July 6, 2026

ADDENDUM 1

ARQ AVIATION

FLIGHT SCHOOL + FBO

A-413

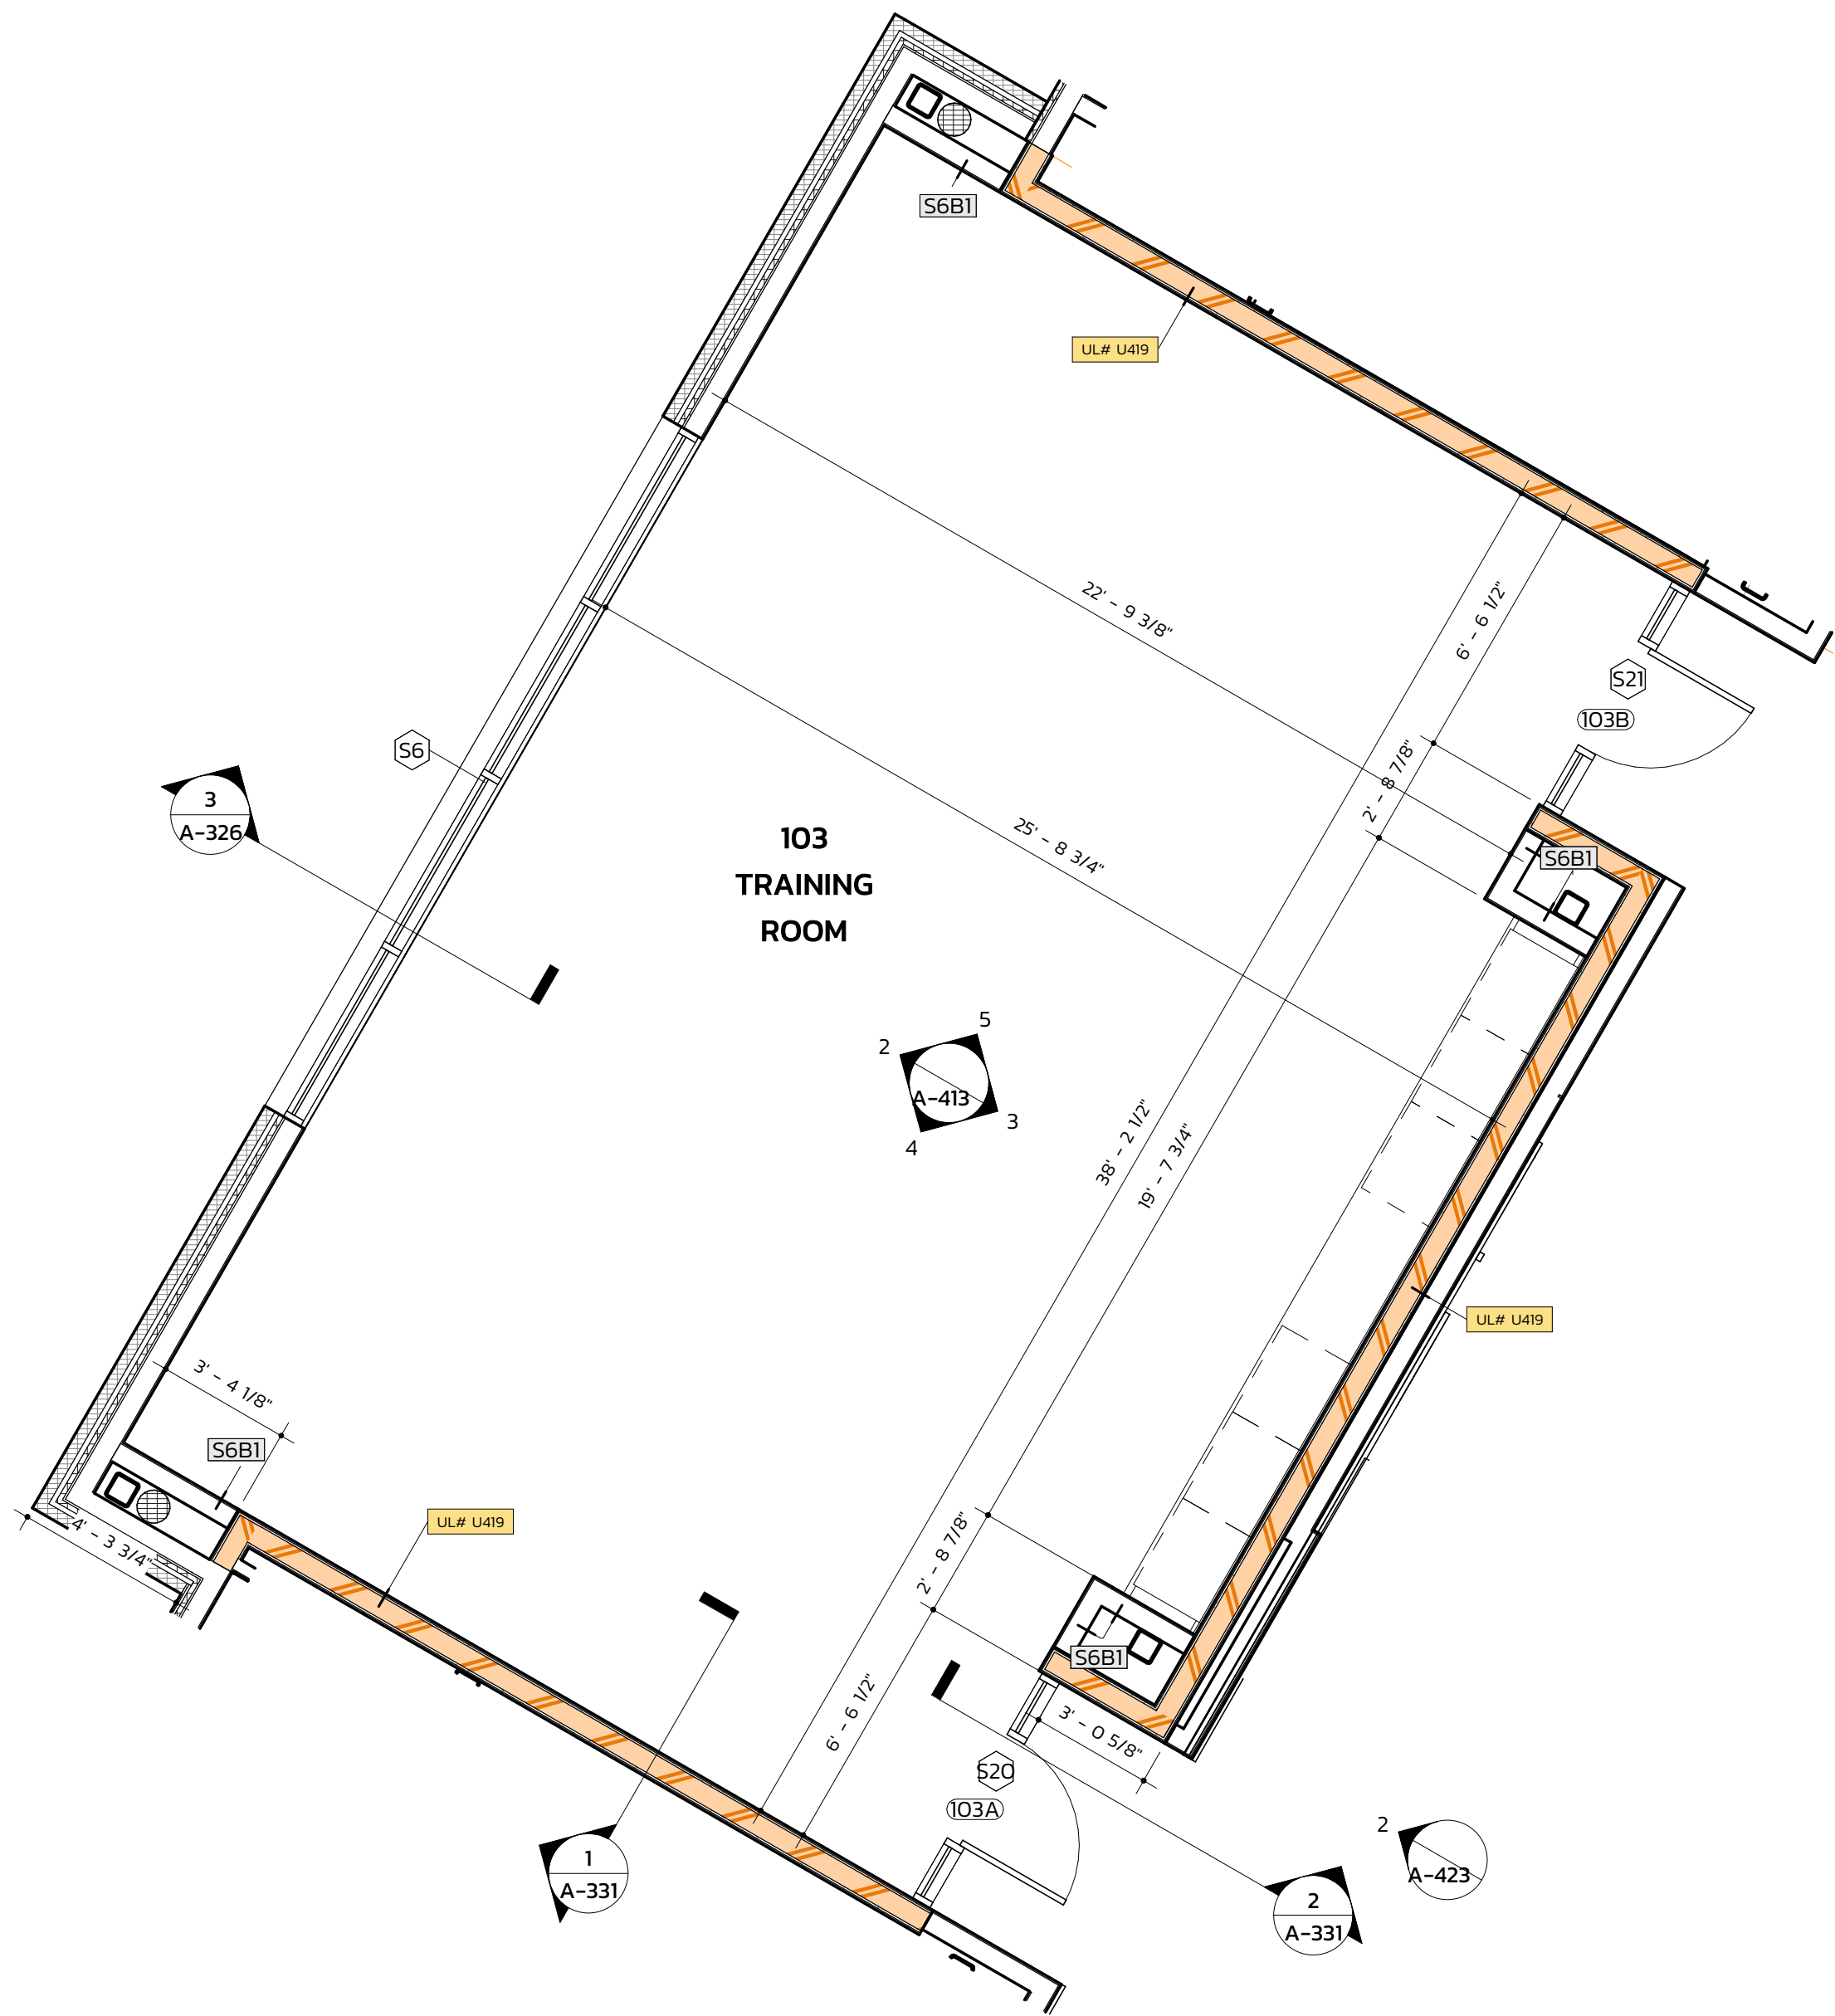
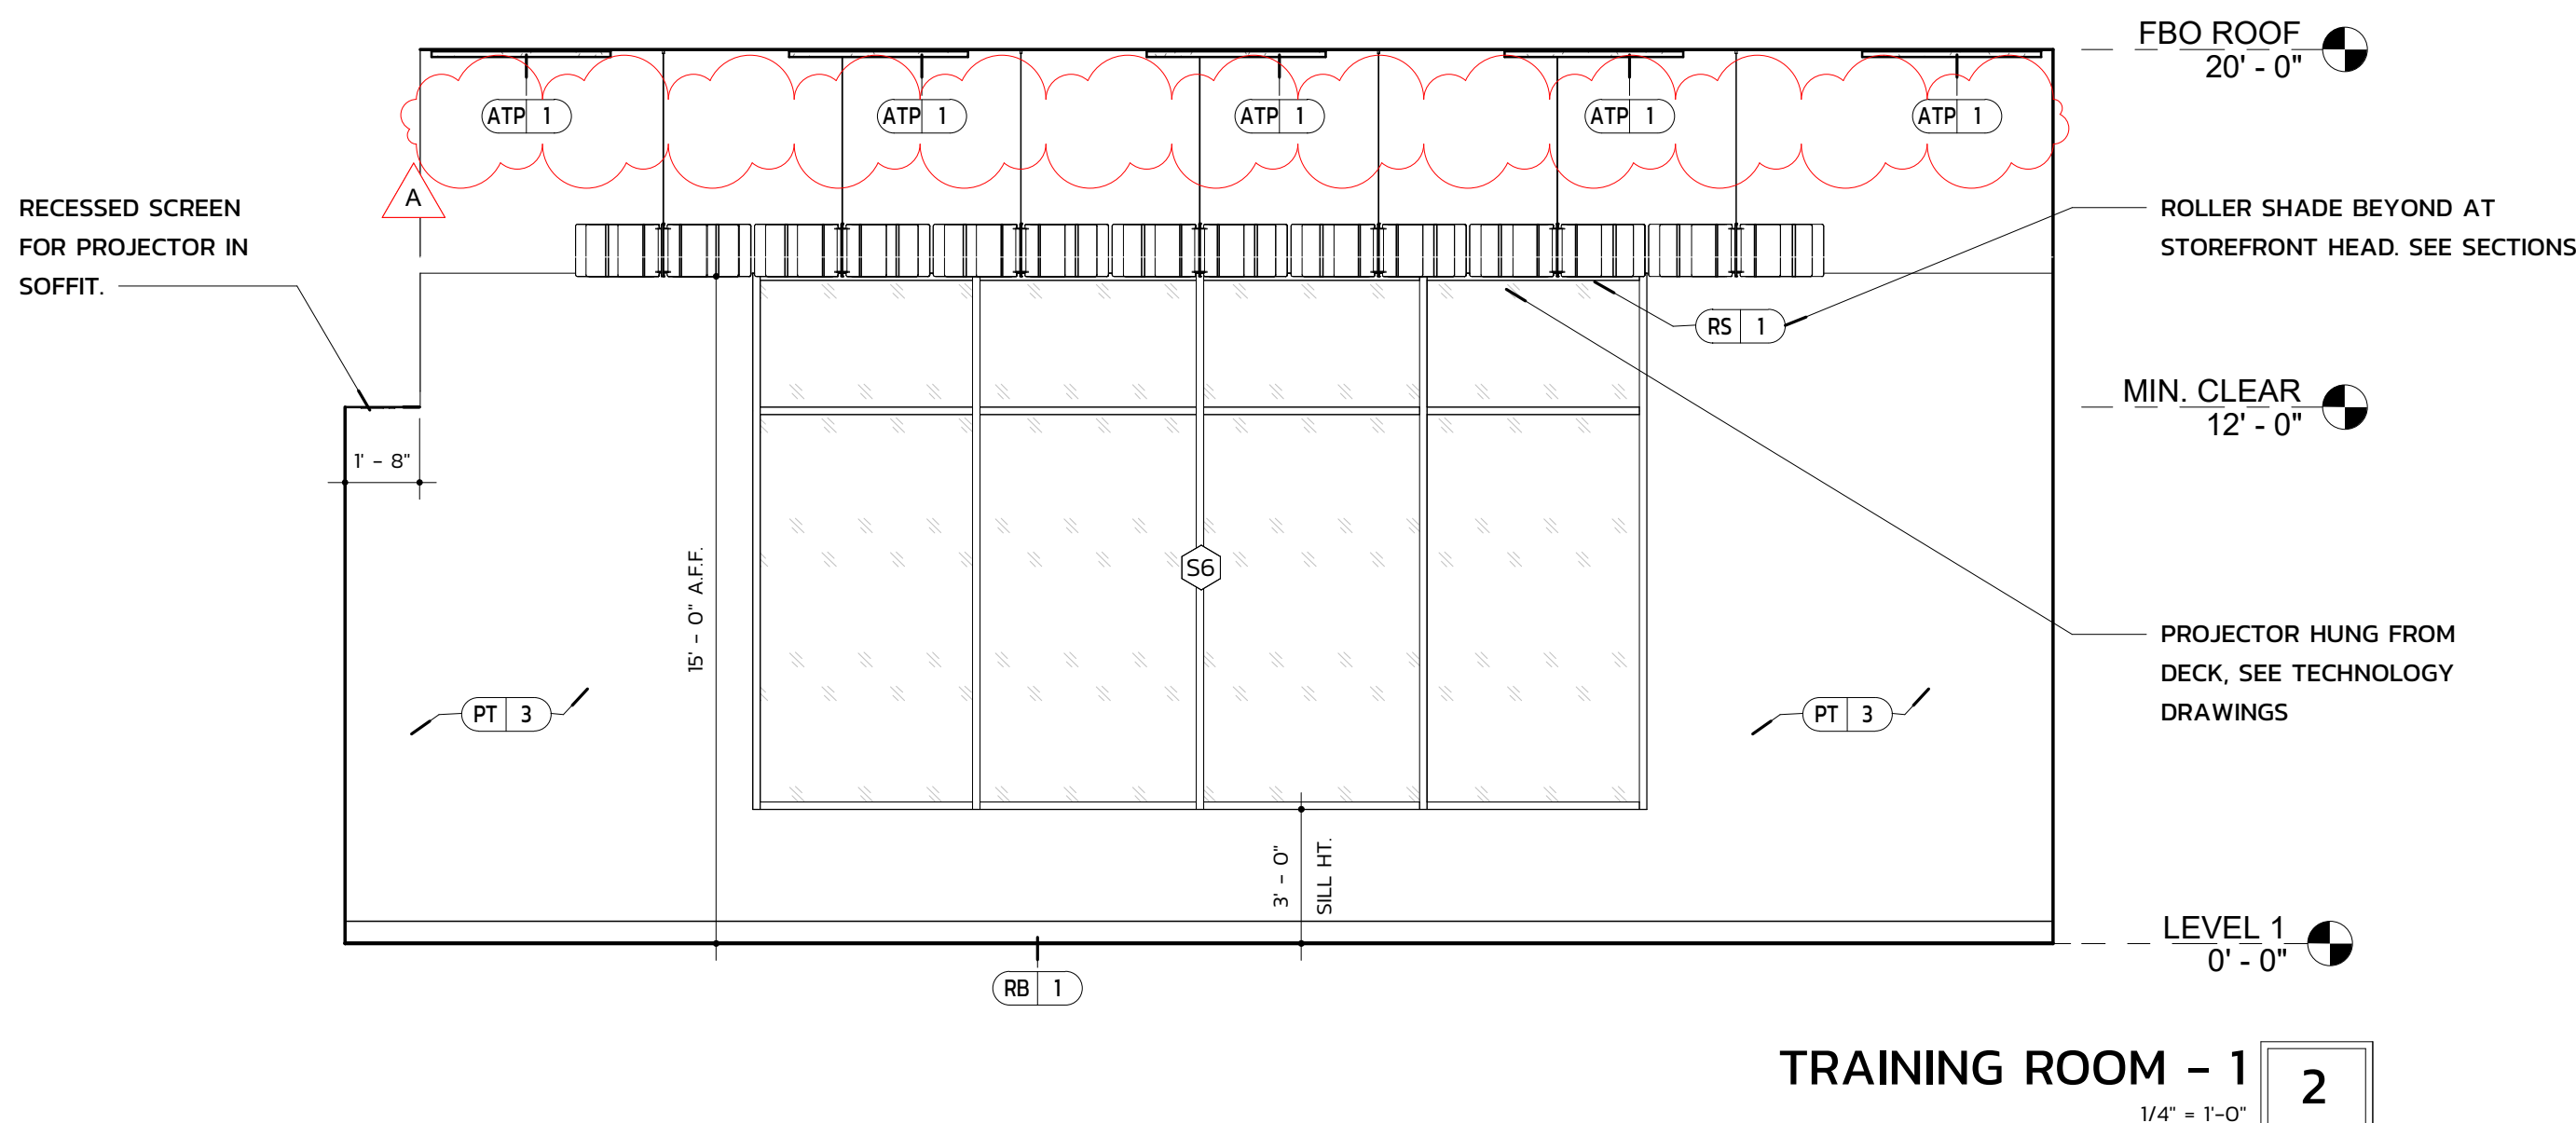
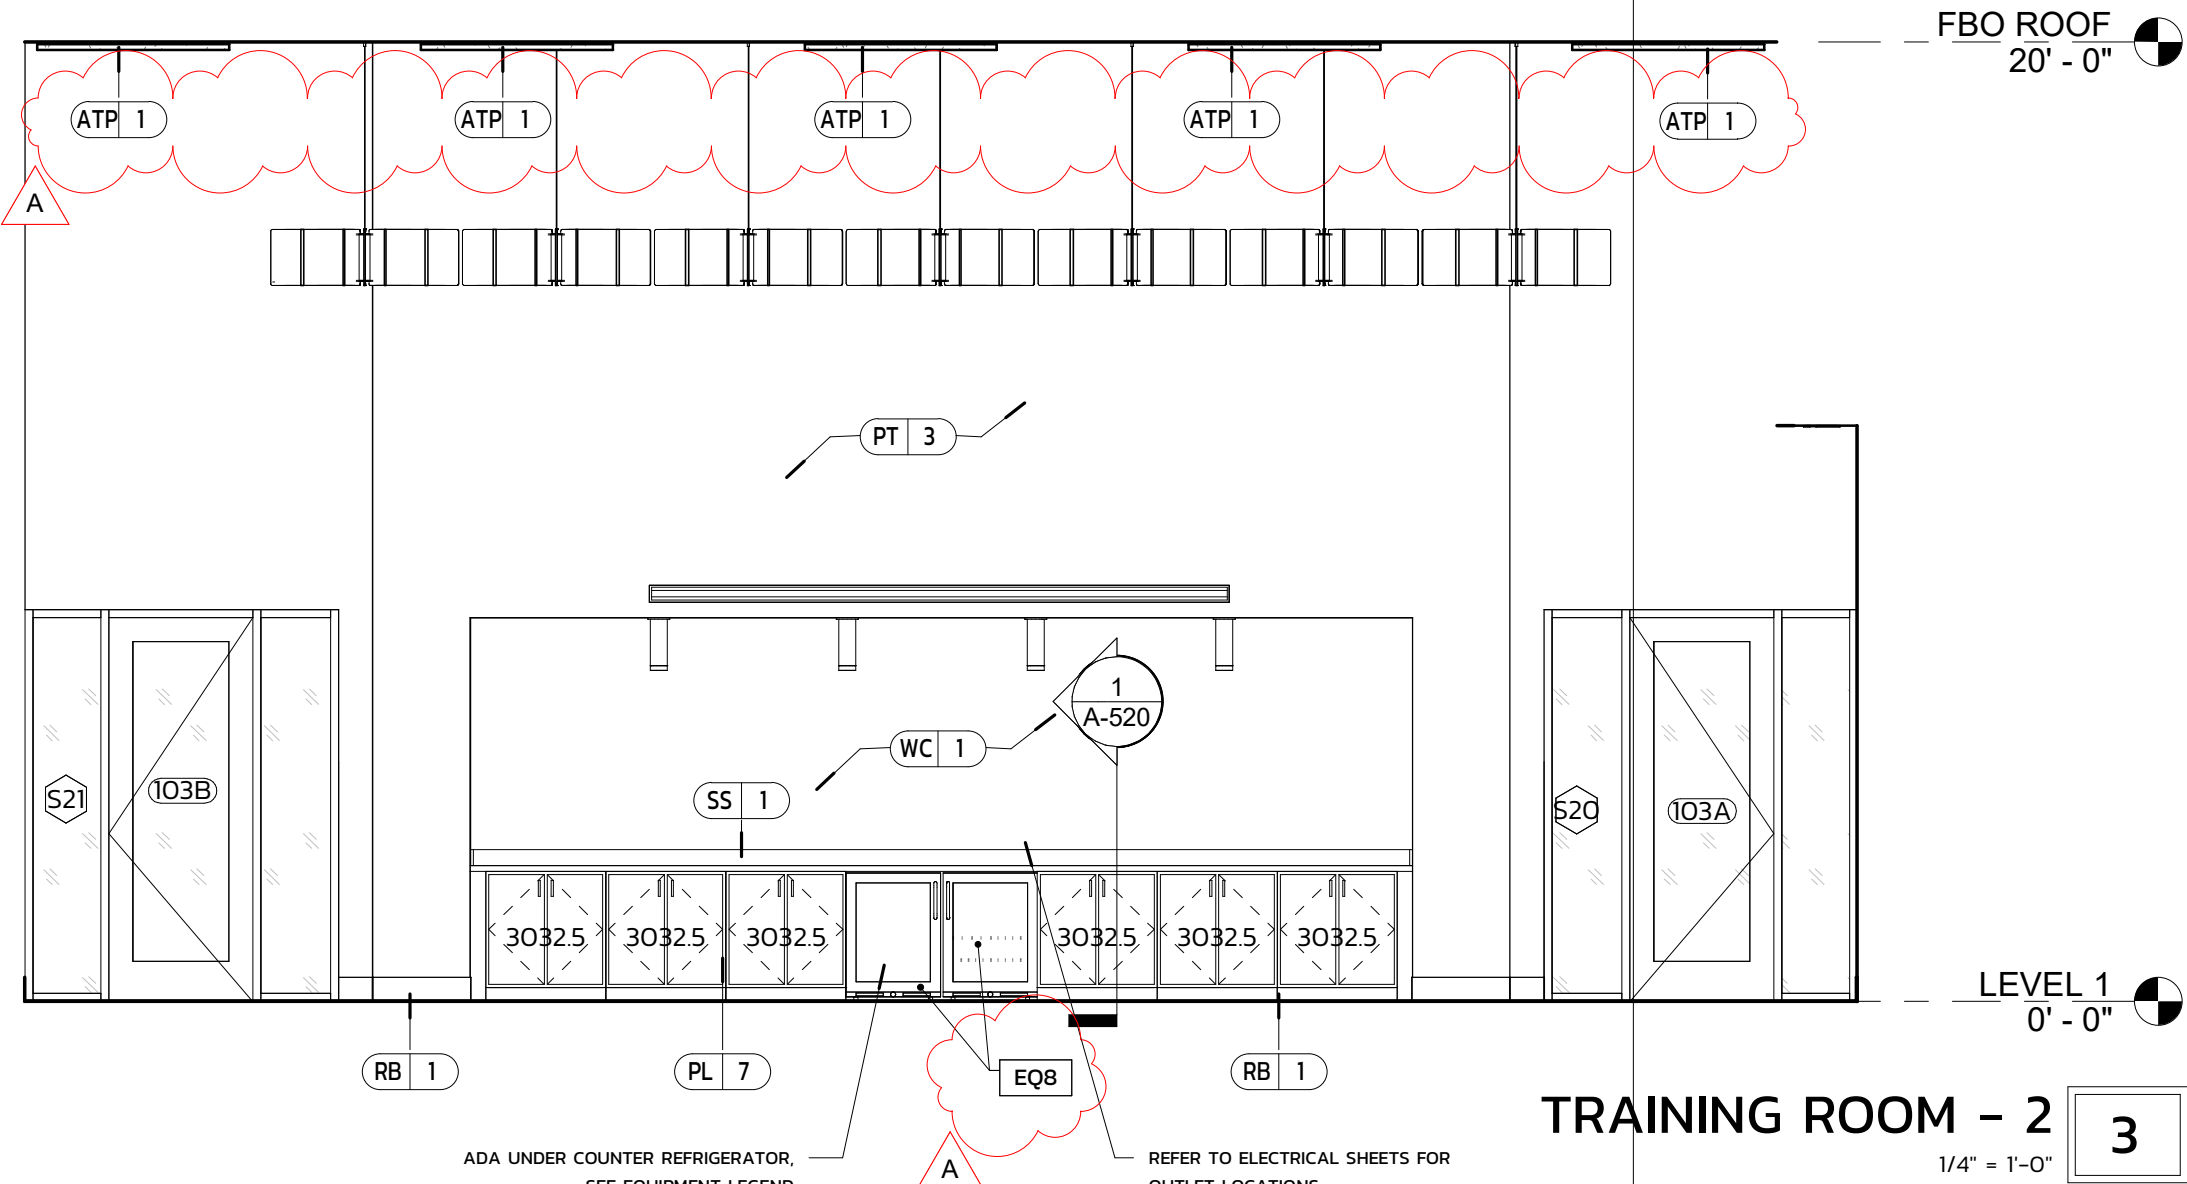
3/A413 detail calls for EQ-9 (docking station) I believe this is labeled wrong and should probably be EQ-8 please clarify -- **YES! EQ8 UNDER COUNTER MINI FRIDGE**
